Product Change Notification

Change Notification #: 117392 - 00
Change Title: Intel® Server System R1208WFQYSR, PCN 117392-00, Label, Product Design, 1100W Power Supply Fan Label Location Change and BIOS/ME/BMC Firmware Update
Date of Publication: January 15, 2020

Figure 1. Previous Label Location

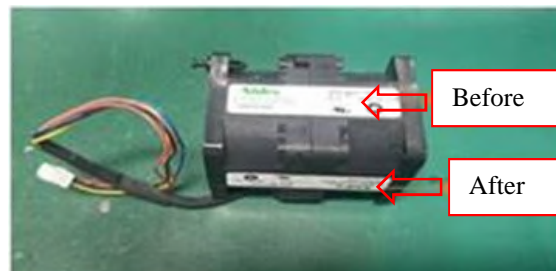
1. The location of the 1100W power supply fan label is being relocated, so that it is covered and protected by the power supply chassis.
